The Rose Dresses Ltd. & Islam Garments Ltd. & Islam Dresses Ltd. (Extension)

17 March 2025

Structural Inspection Report

Observation 01: Lack of material test report and prepared design report needs to be reviewed against lateral loading. (Building -8)

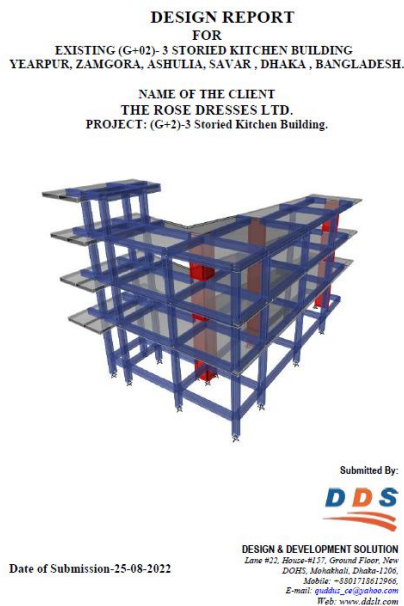
Description: During inspection, no in-situ material strength report was available.

The building engineer is required to perform in-situ material strength testing for the structure and revise the prepared design report based on updated material test report and submit it to RSC for detail review against lateral forces.

Observation 03: Inadequate material test report and prepared design report needs to be reviewed against lateral loading. (Building -10)

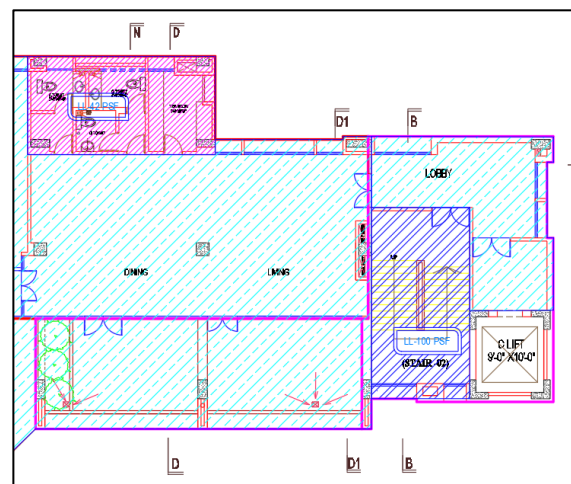
Description: During inspection, 15 sets (Column – 3 sets, Foundation – 2 sets, and Slab – 10 sets) of cylinder test reports were available which didn't meet the frequency of testing requirement as per BNBC.

The building engineer is required to perform in-situ material strength testing for the structure and revise the prepared design report based on updated material test report and submit it to RSC for detail review against lateral forces.
